W140 CHASSIS AUX. FAN PRE-RESISTOR MODIFICATION

PRODUCTION 5/94 TO 8/95

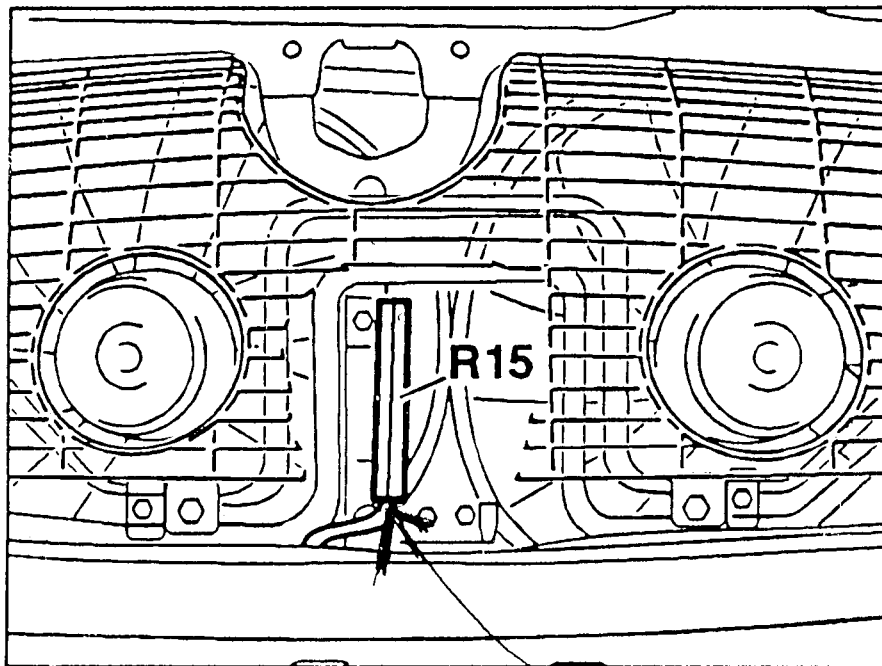
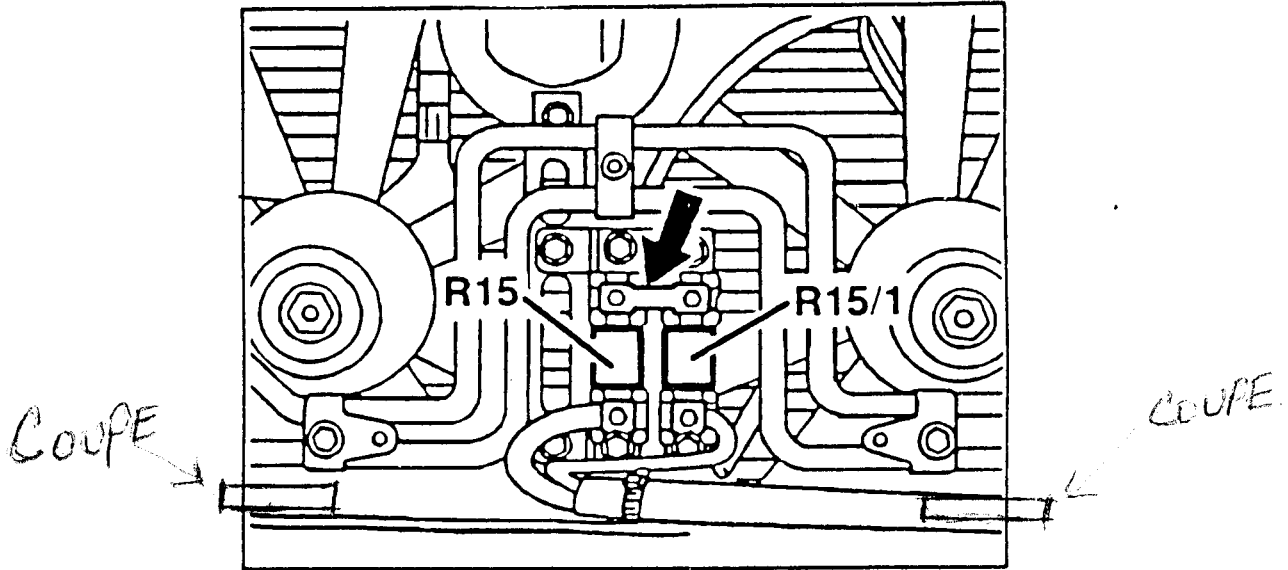
BAD

CUT HERE  
& MODIFY AS  
ABOVE

000-158-37-45---PRE-RESISTOR

000-158-39-45---PRE-RESISTOR

002-546-30-40---CONNECTOR

140-620-71-14---BRACKET

913011-006000---NUT-----4 REQUIRED

914126-006001---SCREW-----2 REQUIRED
